GM CUSTOMER CARE AND AFTERSALES
DCS3166
URGENT - DISTRIBUTE IMMEDIATELY

Subject: 14082 - Noncompliance Recall
Passenger Side Instrument Panel Performance

Models: 2009-14 Chevrolet Express and GMC Savana 2500/3500 Series
Vehicles Equipped with Front Passenger Side Airbag (AK5) and
GVWR 10,000 pounds (4536 kg) and Below

SUBJECT: Passenger Side Instrument Panel Performance

3785217

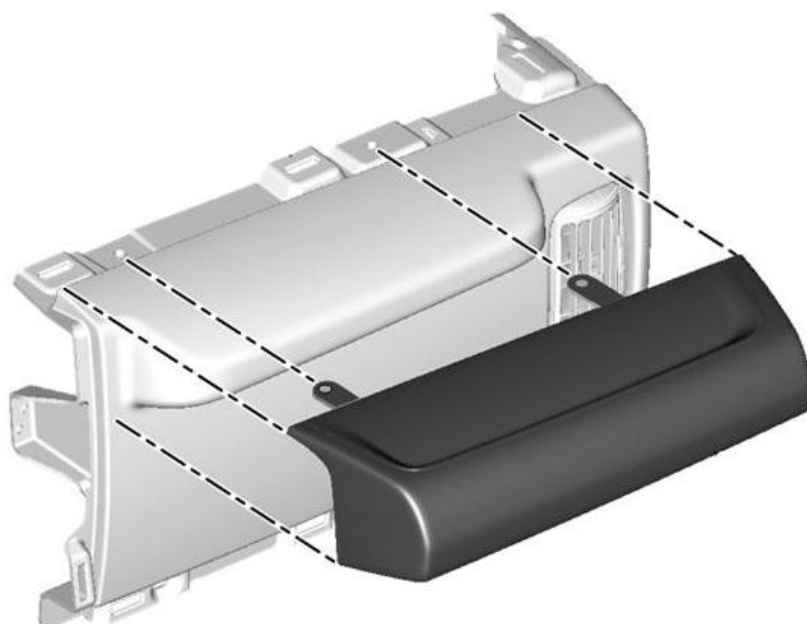
1. Remove the instrument panel upper trim pad. *Refer to Instrument Panel Upper Trim Pad Replacement in SI.*

2. Remove the upper two screws that attach the instrument panel pad to the instrument panel bracket.
